PLANS AND DOCUMENTS referred to in the PDA DEVELOPMENT APPROVAL

Approval no: DEV2025/FLA/4175
Date: 06 February 2026

PROJECT
HERCULES STREET

SITE ADDRESS
19 HERCULES ST HAMILTON, BRISBANE QLD 4000

DRAWING TITLE
SECTION EE

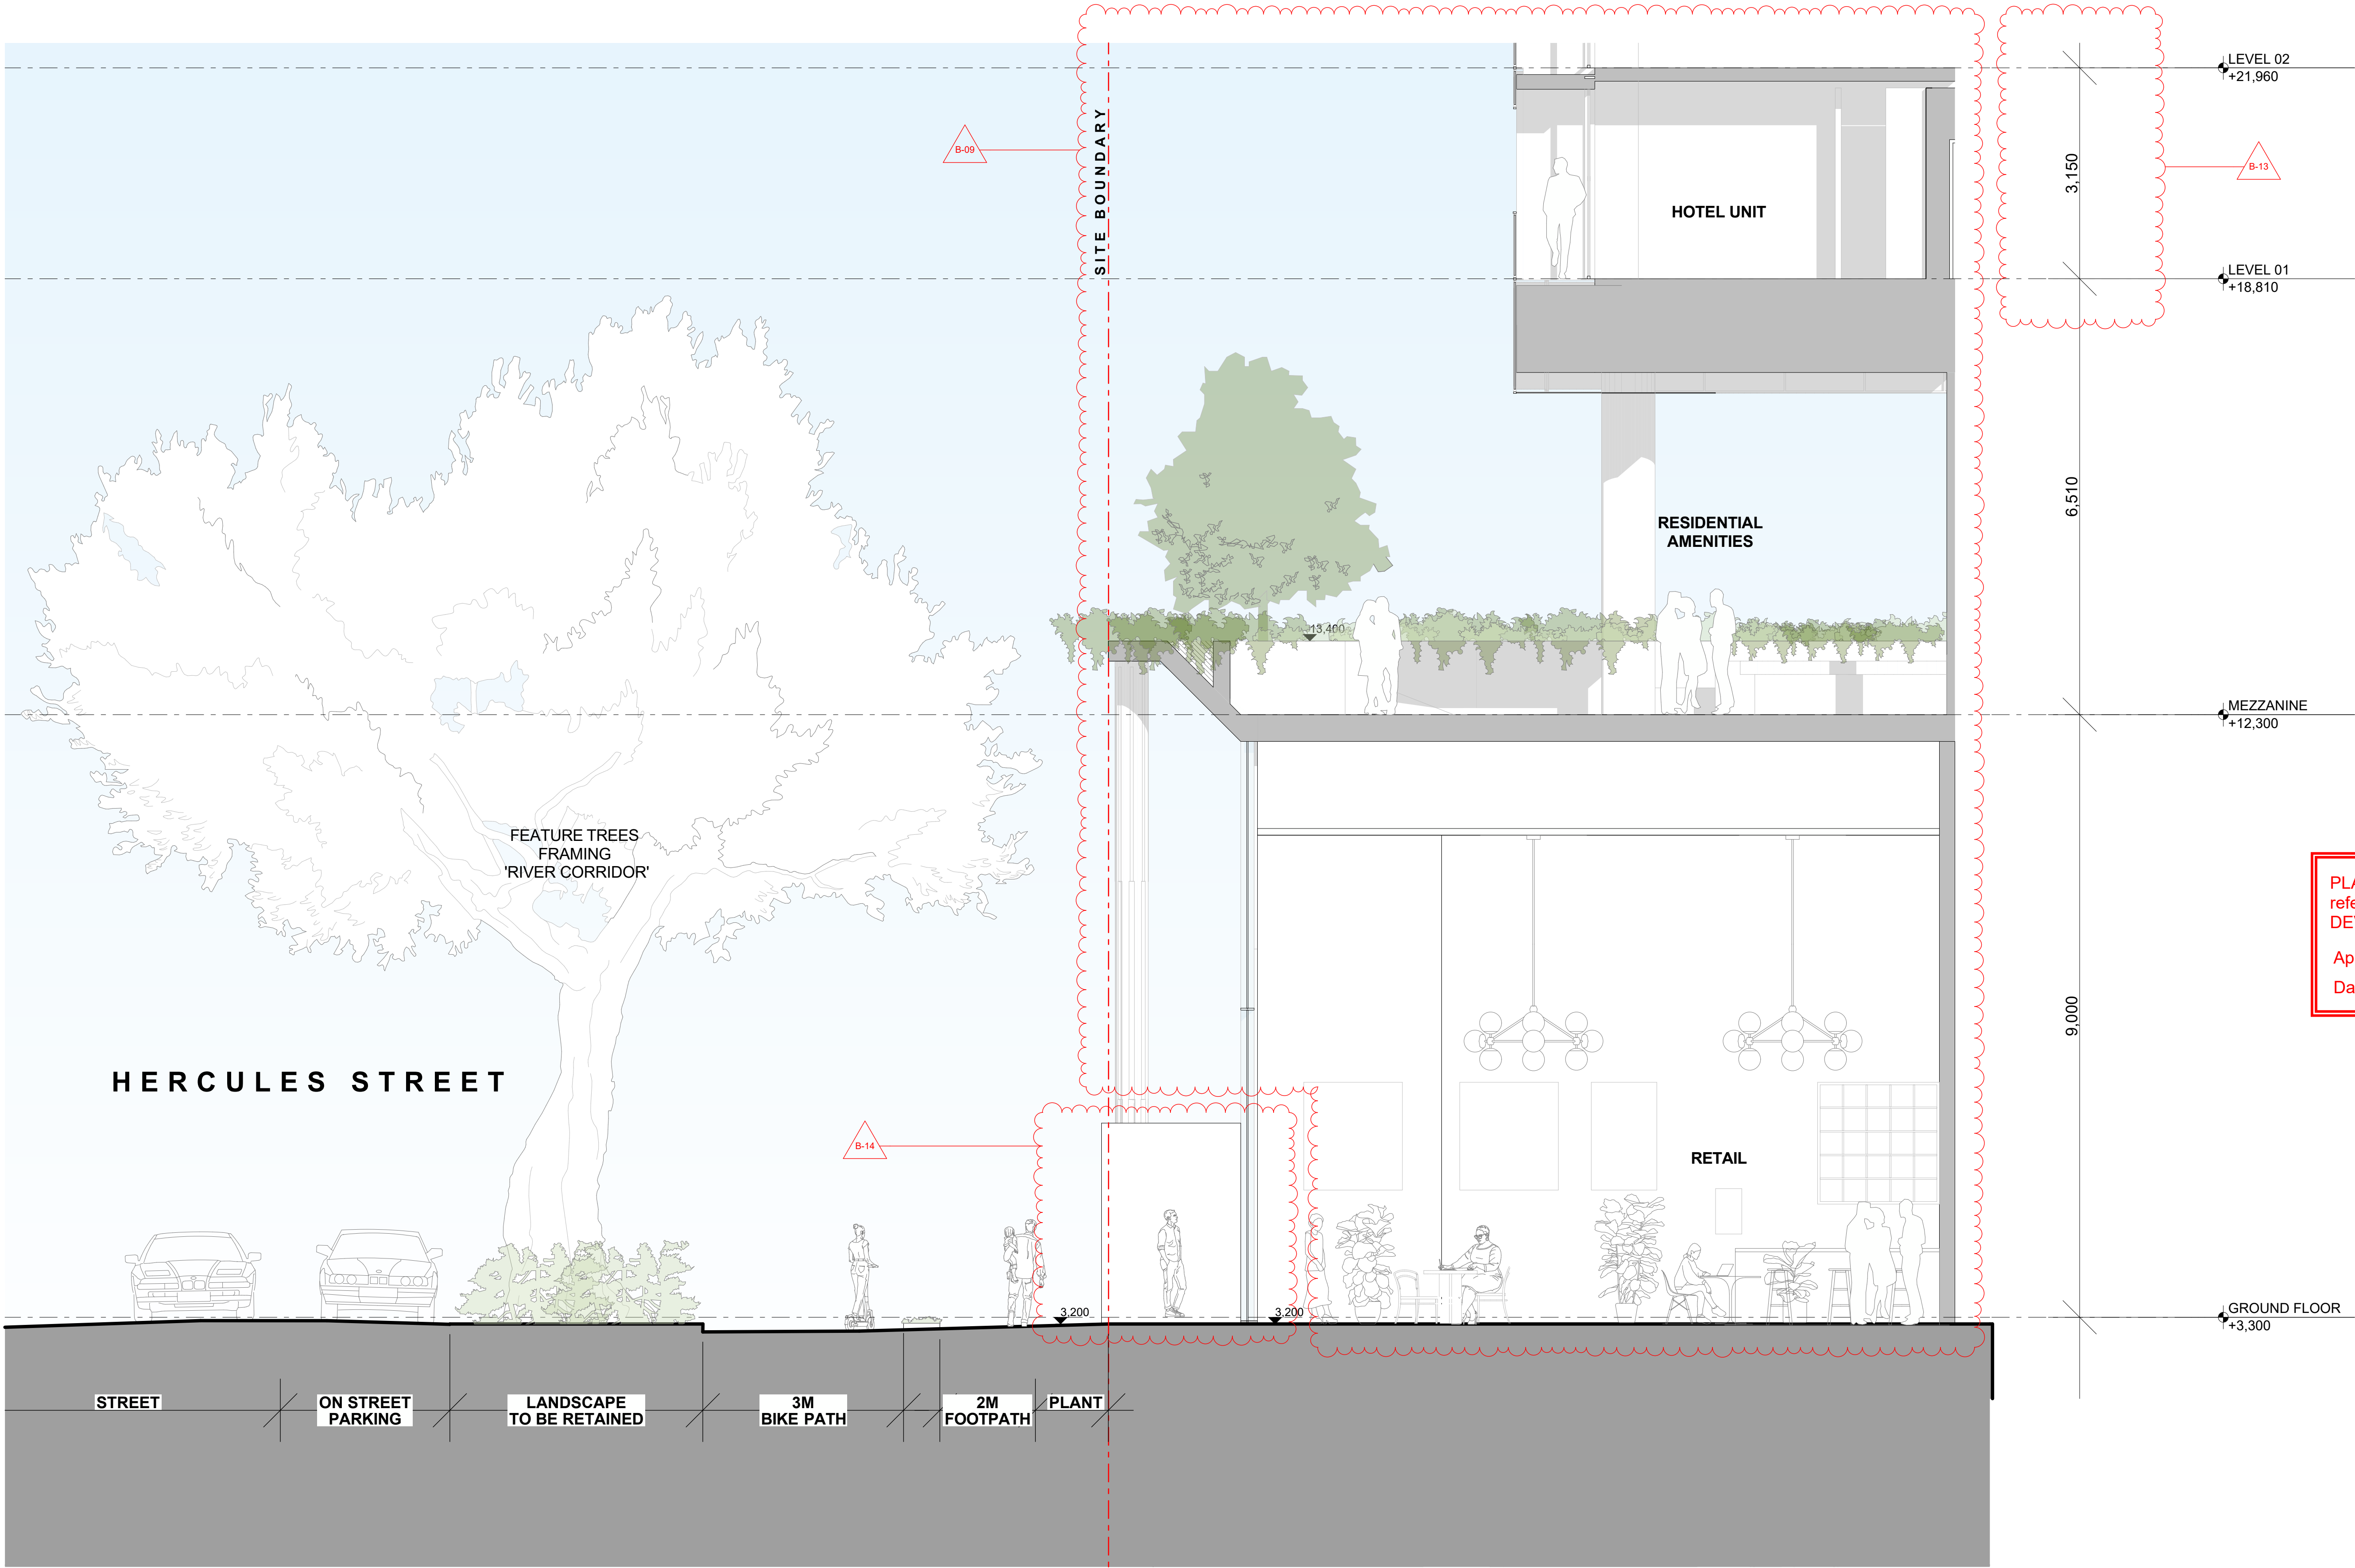
CHANGE	DESCRIPTION
B-09	CHANGE OF USE TO HOTEL FROM L1-L10 (SKY GARDEN CONVERTED TO HOTEL USE)
B-13	FLOOR TO FLOOR HEIGHT CHANGES
B-14	TRANSFORMER ENCLOSURE AMENDED FOR SERVICES

SECTION FF

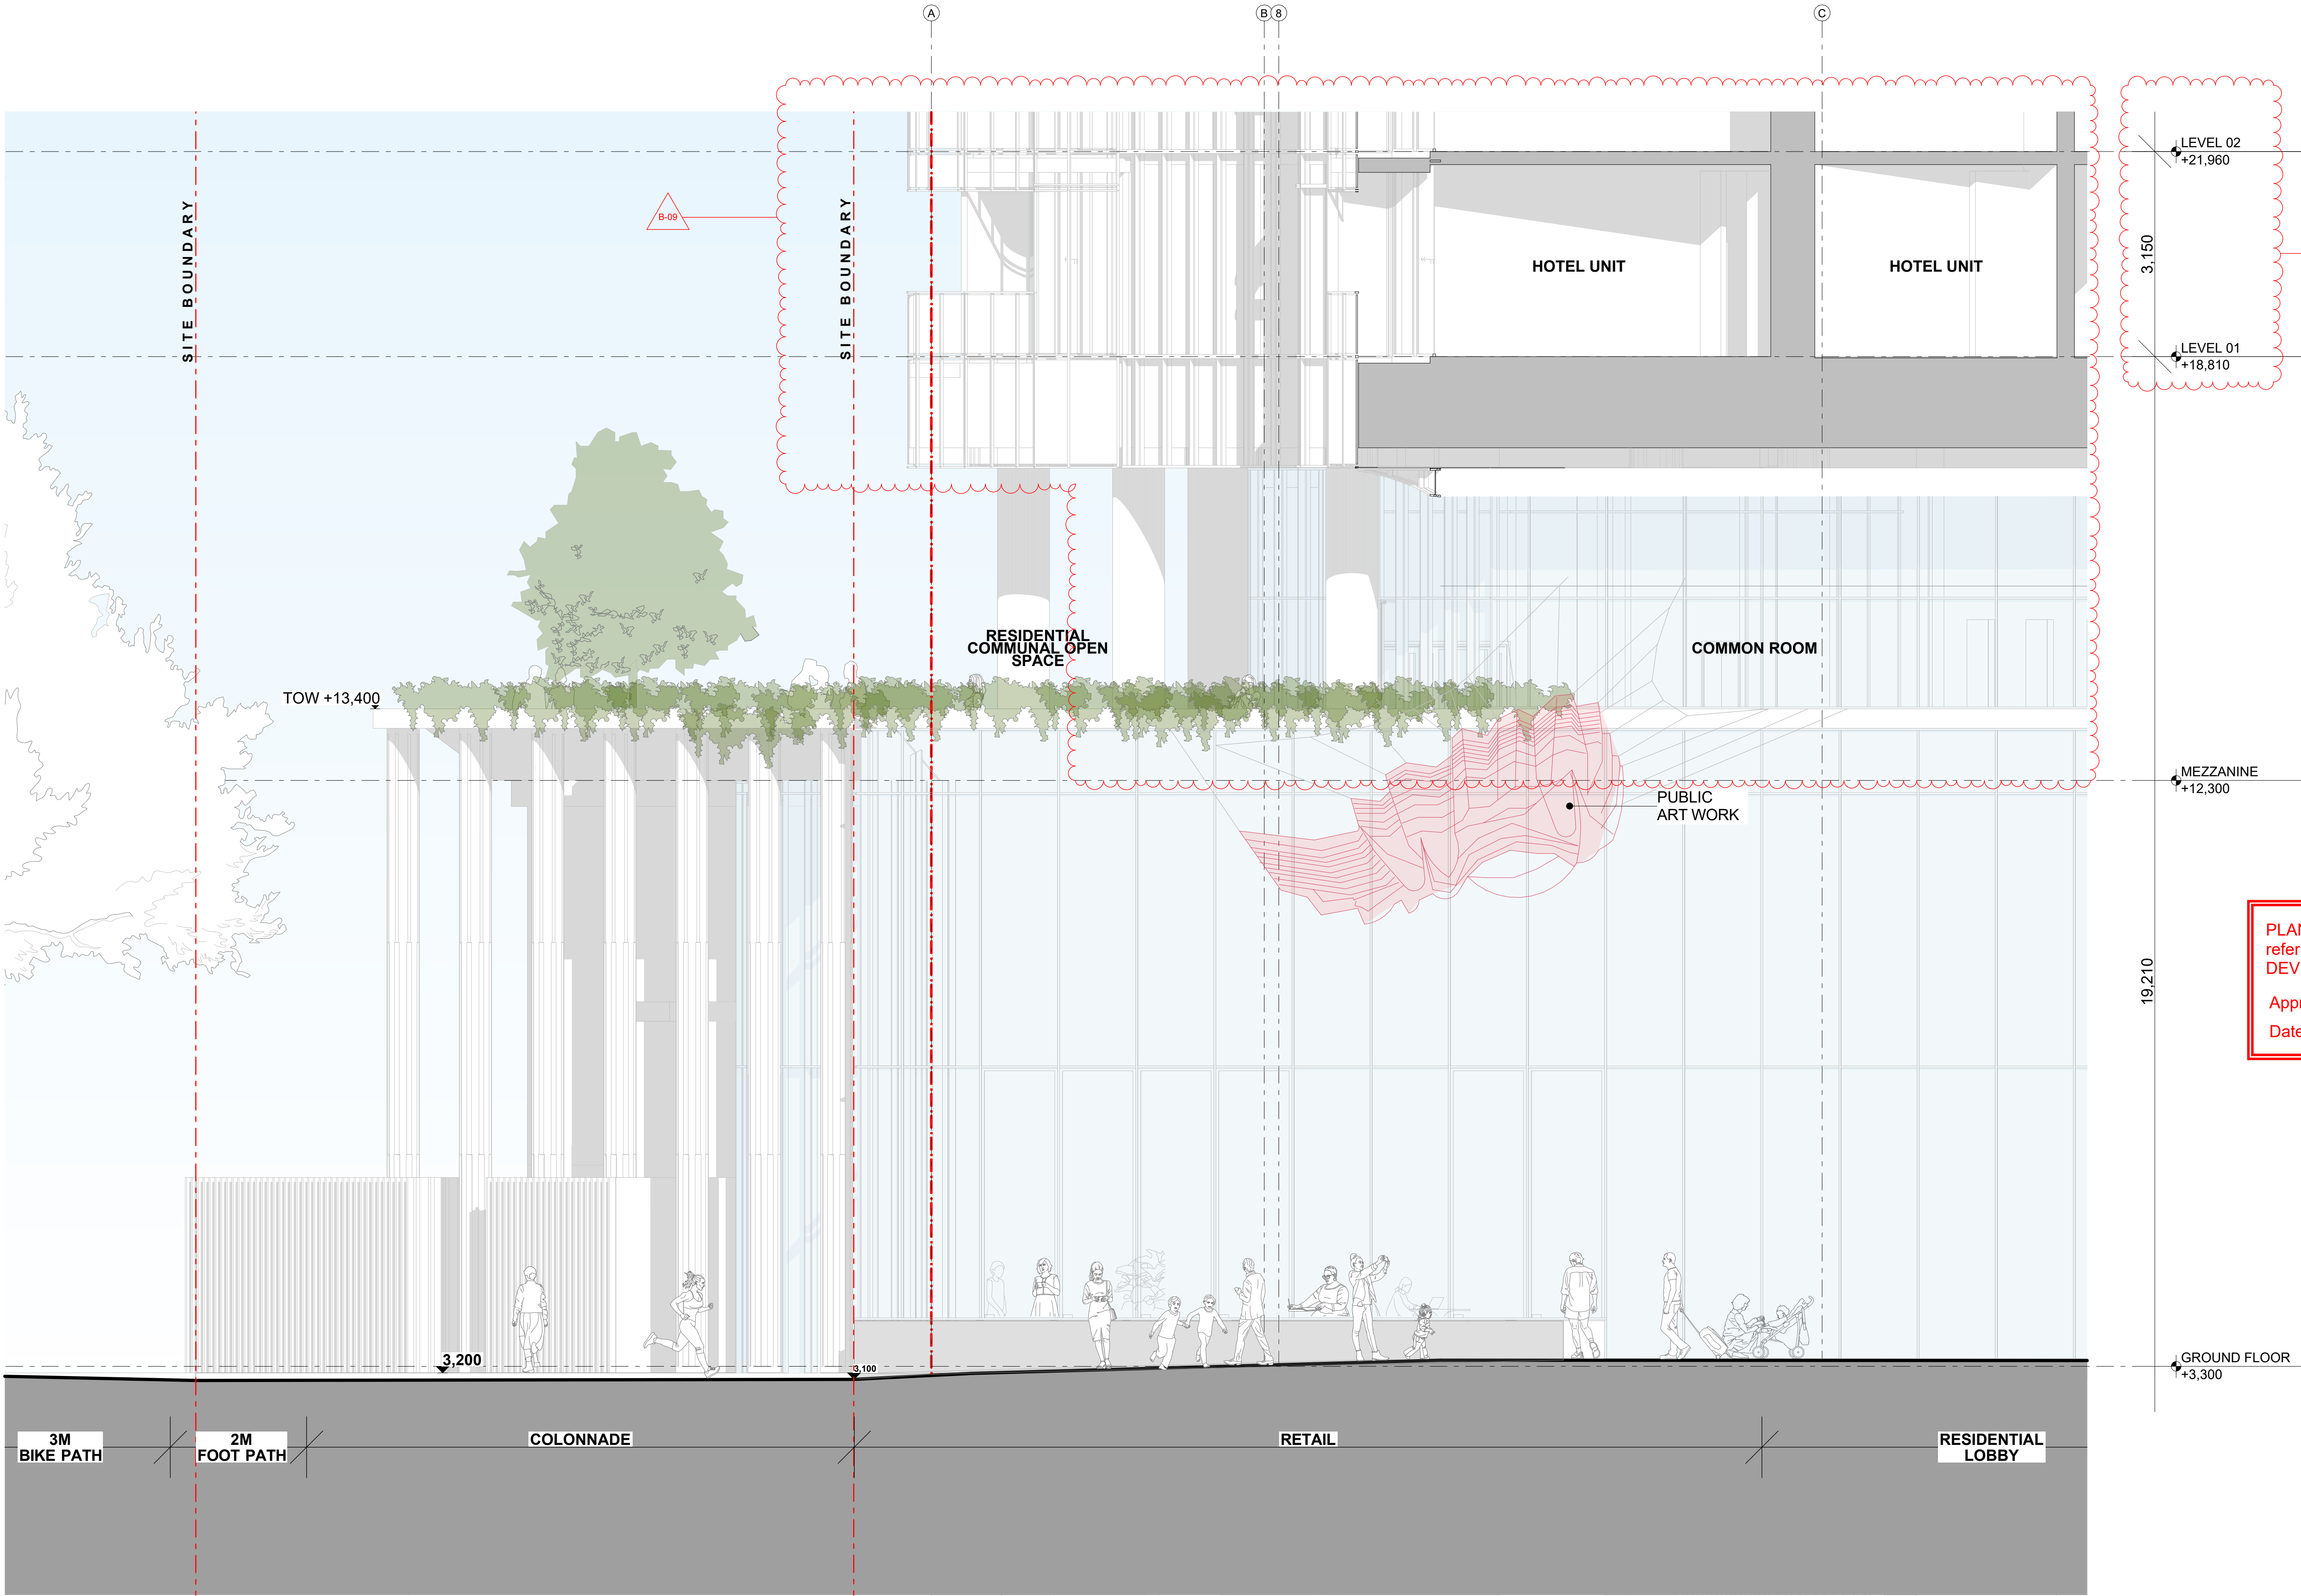
CHANGE	DESCRIPTION
B-09	CHANGE OF USE TO HOTEL FROM L1-L10 (SKY GARDEN CONVERTED TO HOTEL USE)
B-13	FLOOR TO FLOOR HEIGHT CHANGES
